HIDEOUT, UTAH PLANNING COMMISSION SPECIAL MEETING AND PUBLIC HEARING

Staff Review of Plan Submittal

Re: Deer Springs – Revised Phases 2 & 3 (and partial 4) Plan Review (Renamed Phases 2 and 2B)

Staff Review for Planning Commission

**Full Site and Phasing Plan for Deer Spring
(and Google Earth's Elevation Diagram – Slope from Jordanelle Parkway to SR 248)**

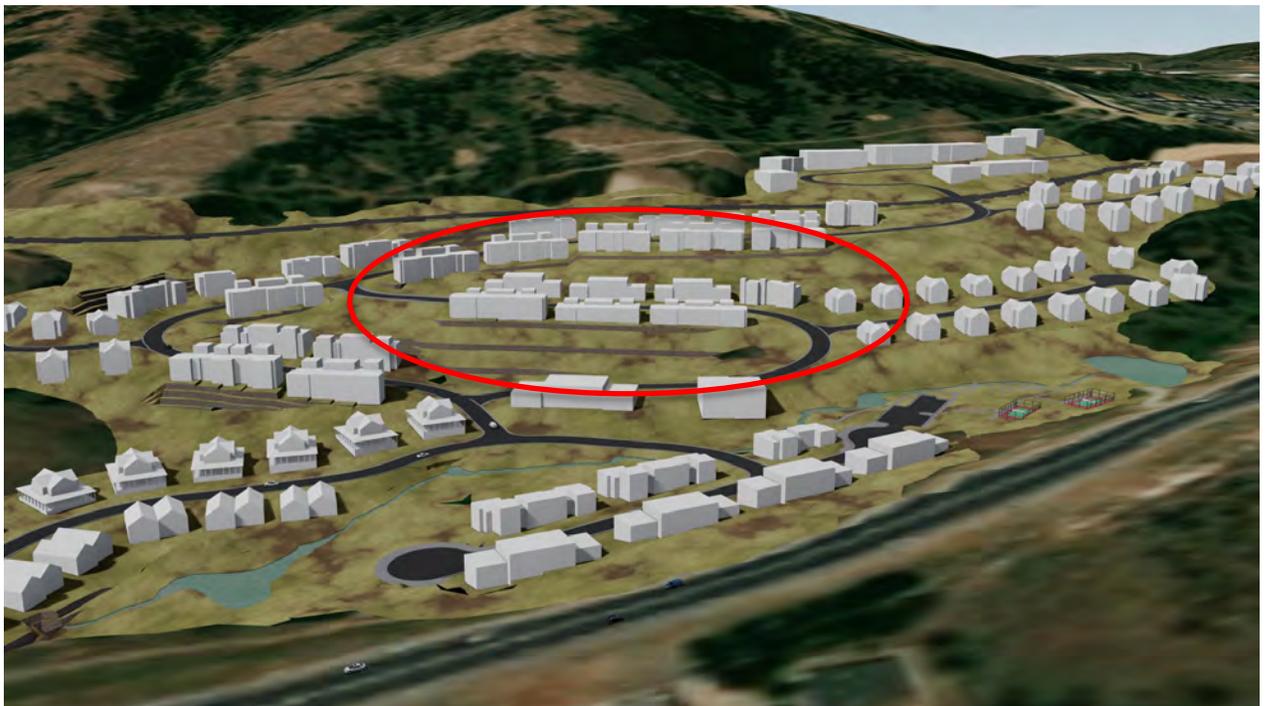
- a. The Applicant worked with staff to eliminate the massive retaining walls that were part of the initial submittal. One series of terraced retaining walls exceeded a height of 60'-0". At time of writing this staff report, the final heights of the newly proposed retaining walls were not available; however, the Applicant will present their newly configured plans and point out all substantive changes.

- b. The following images reflect the 'before' and 'after' conditions based upon changes made by the Applicant. These will be explained in detail at a presentation by the Applicant at the Planning Commission meeting.

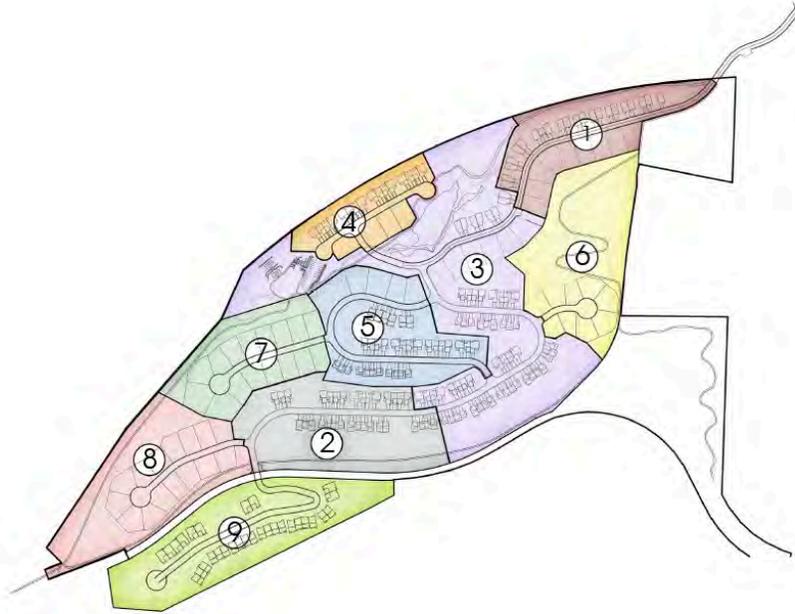
1. The proposed amenities for the park have not been provided and should be included in the construction plan set. The following list includes the amenities approved and agreed upon per the Master Development Agreement (MDA):

2. The Applicant shall also provide detailed construction drawings for the park including the amenities outlined above as well as the driveway, parking lot, walkways, etc. A full landscape plan is required as well; including screening from SR 248.

Exhibit A – 2010 Master Development Agreement (MDA) RSPA Zoning Map

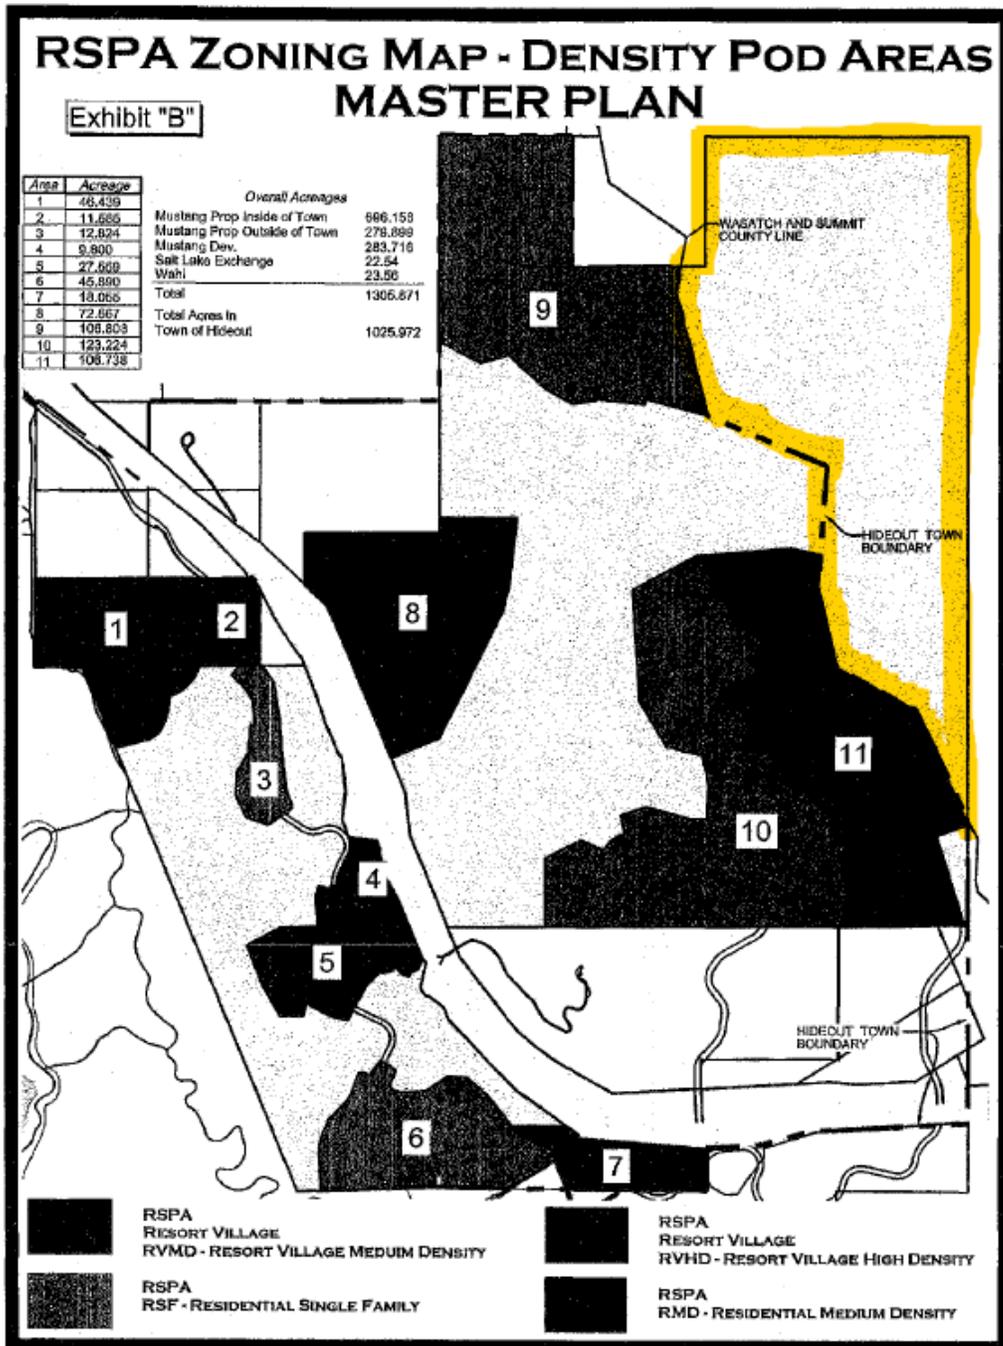
5. Zoning: The RSPA (Resort Specially Planned Area) map is referenced several times relative to the overall 2010 MDA. The map is contained in Exhibit B. A color rendition should be provided for Staff review since the black and white copy makes it hard to decipher the exact locations of specific density/subdivision pods.

- a. The MDA's recitals confirm the zoning for the entire area is RSPA (Resort Specially Planned Area) with specifically defined 'density pods' located throughout the entire district. The map, Exhibit B, depicting these areas is not clear in terms of sub-zoning classifications for the 'density pods' since the Town has only been provided with a black-and-white copy that doesn't allow the reader to decipher specifically designated areas. A color map that clearly outlines these 'density pods' shall be provided.

Exhibit B – Proposed subdivision plat for Shorelie Phase 3

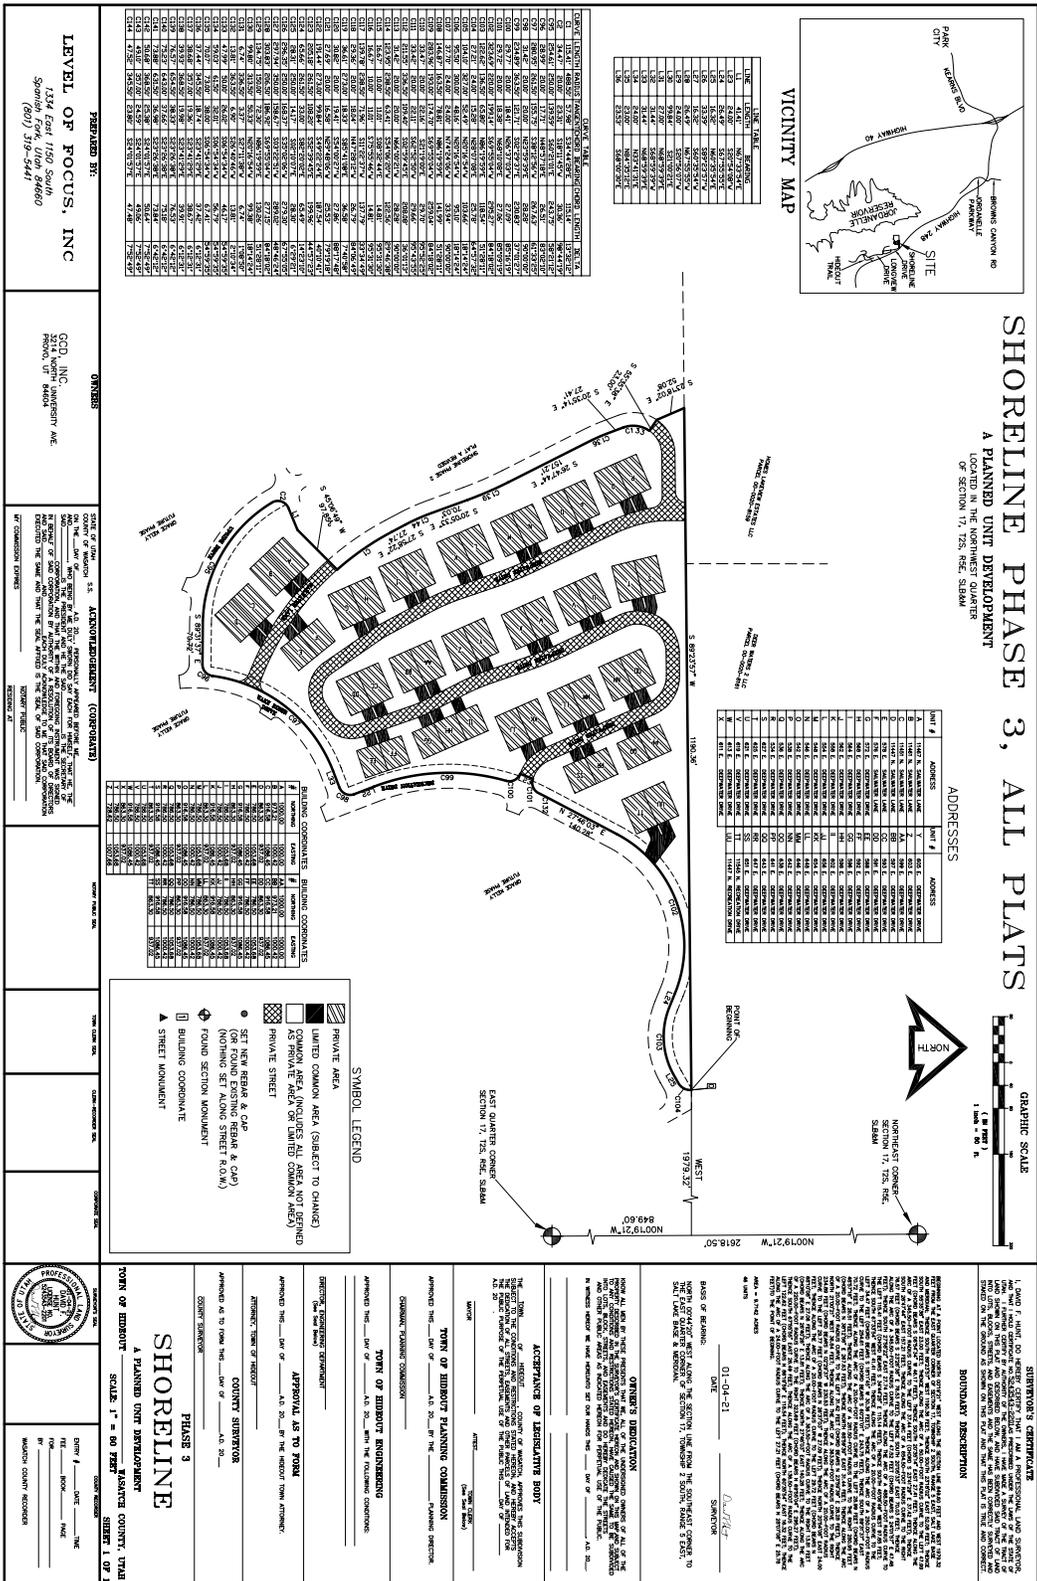
2. The width of the proposed roads (pavement/cart way) as well as right-of-way area should be clearly noted on the supporting plans.
 - a. For Phase 3, the roads are proposed at 18'-0" of asphalt and 5'-0" of curb and gutter for a total of 23'-0" in width. The Applicant must confirm that this is correct for all roadways proposed. The Applicant must further confirm that curb and gutters will be provided for all proposed roads.

- e. The Phase 2 (Amended) Subdivision is missing *any* reference to road widths and rights-of-way widths. These must be provided.
 - f. The vertical alignment of the road connecting Shoreline Phase 3 (north side) and Lakeview Estates must be adjusted to match the approved Lakeview Estates construction plan set.

8. The plans illustrate only two (2) proposed retaining walls for Phase 3 and none for Phase 2 (Amended). The Applicant shall confirm whether this is accurate or if more are proposed:

- The Applicant shall confirm the maximum height of this wall; it appears to be between 6'-0" to 8'-9" high at its highest point.
- c. The northern and southern loops of Deepwater Drive, Sailwater Lane, and Upside Drive appear to have very steep slopes and may require retaining walls. The Applicant shall provide the slope in these areas as well as the proposed slope stabilization mechanisms.

The Applicant submitted a site plan with the location of the retaining walls identified. The walls do not meet the Town Code requirements in terms of maximum height for a single wall; the proposed walls range in height from 8'-0" to 10'-0". Some of these walls are located along the property lines and very close to proposed retaining walls for the adjacent subdivision (Lakeview Estates). These may need to be relocated and/or reconfigured. Staff will work with the Applicant to determine if terracing is possible to reduce the height of the walls. This may prove difficult given the number of units proposed on the site; the density is quite high and may be physically impossible to execute. The Applicant has indicated that he does not have to meet the Town Code requirements (only those of the 2010 MDA) and since there were no specific requirements contained within the MDA, he indicated that he would like to proceed with his plans as presented.

SHORELINE
PHASE 2
LANDSCAPE PLAN
Hideout Canyon, UT
page 4

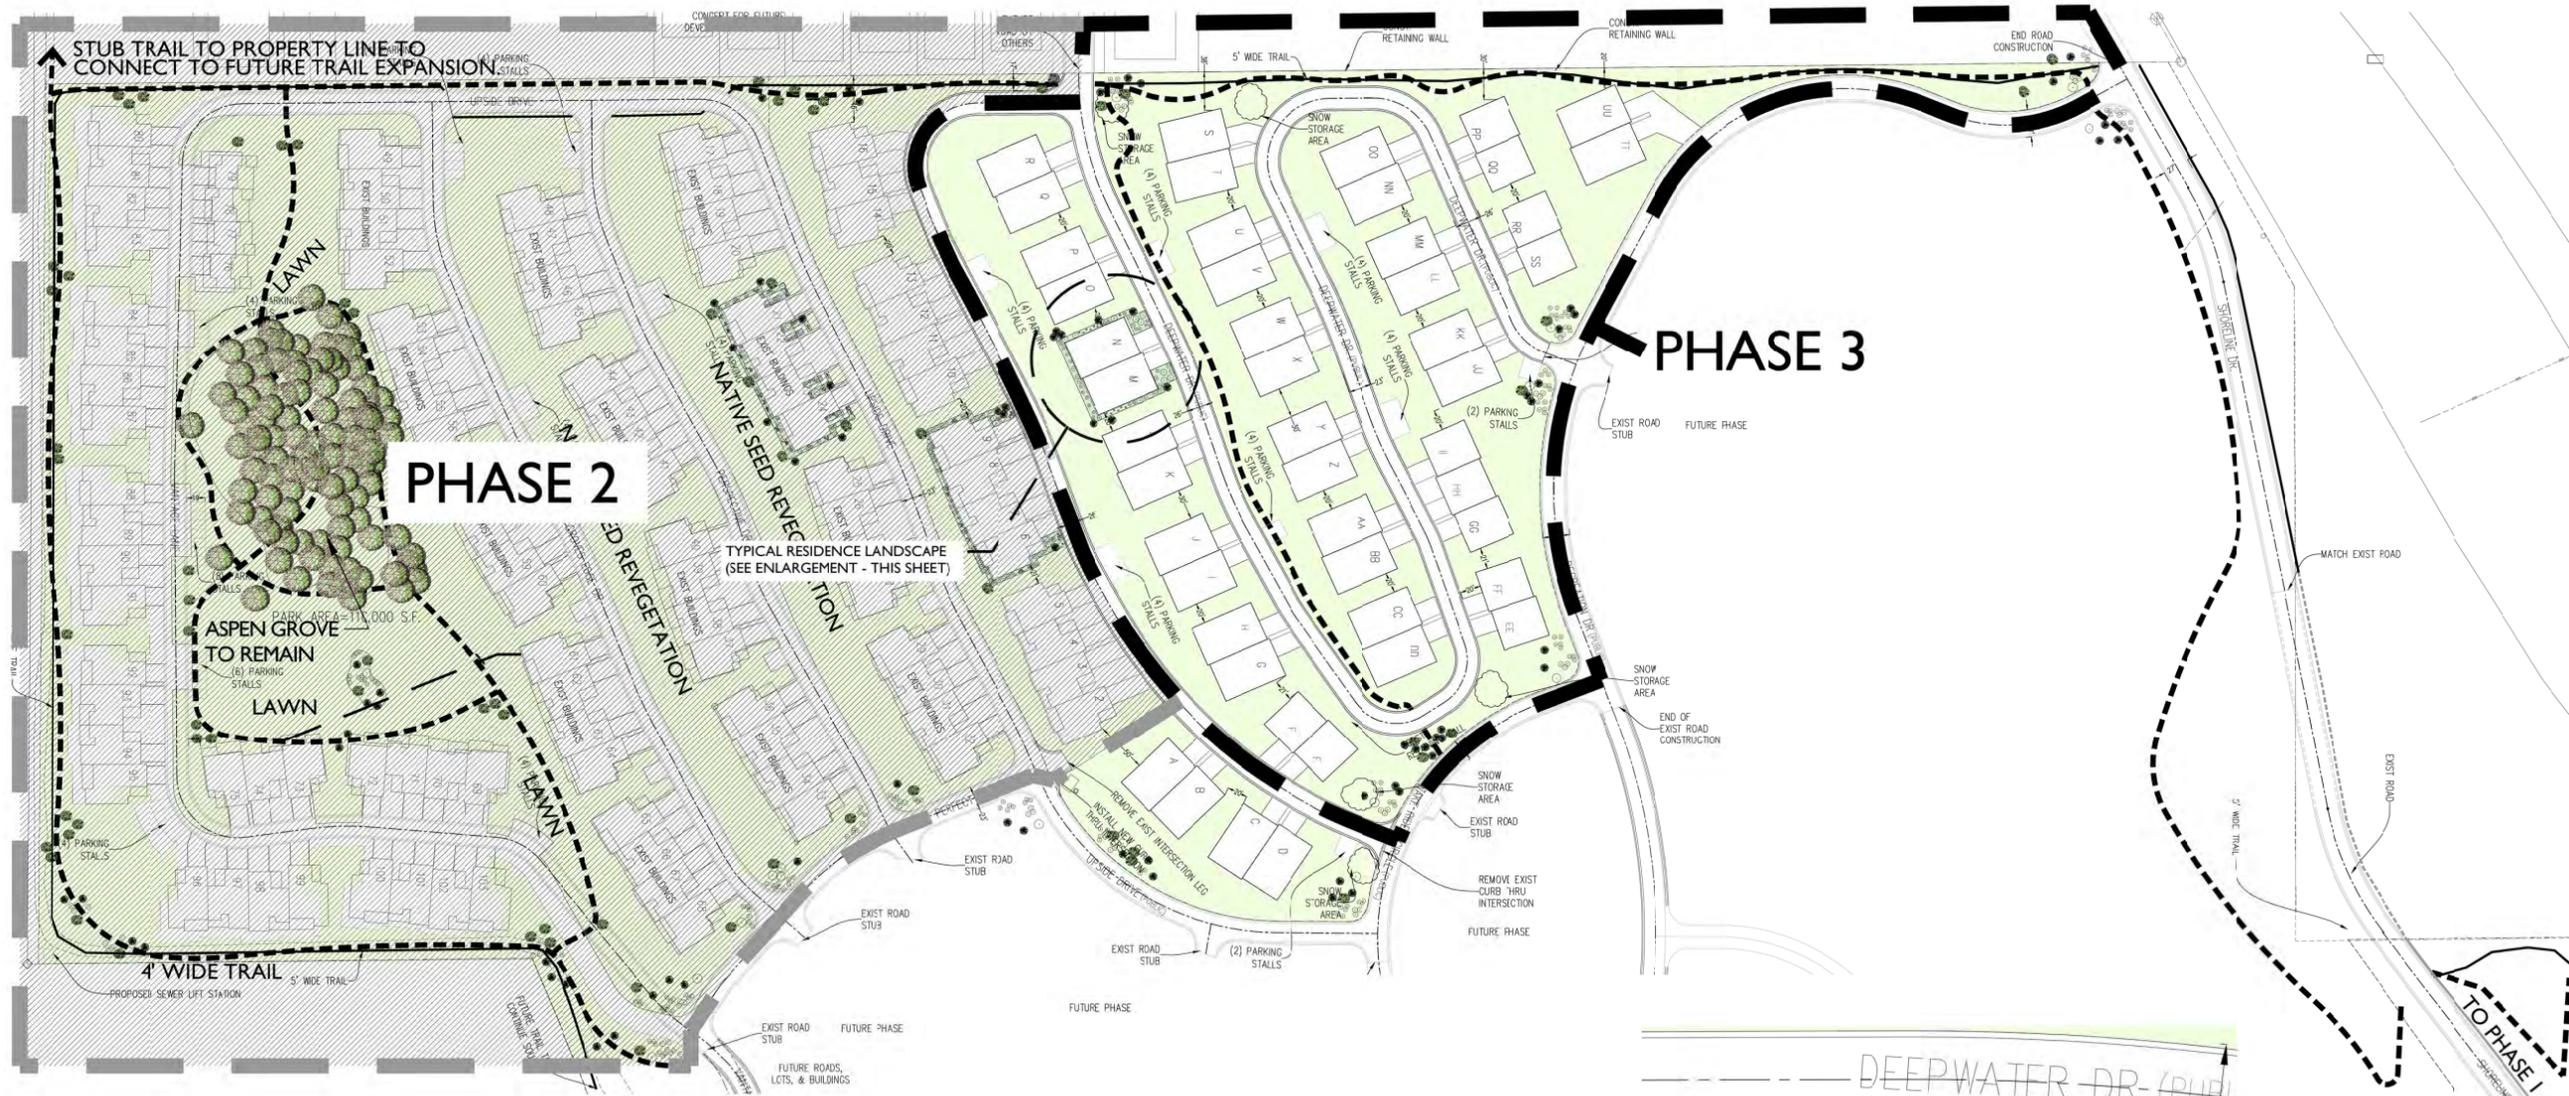
The Applicant submitted a Landscape Plan with some specific planting typology for sample units. The plan is not detailed enough for the final submittal. The Town will require additional information and detail specifically for some of the common areas (which should be re-vegetated with native vegetation) and additional variation for the limited common areas around the proposed units.
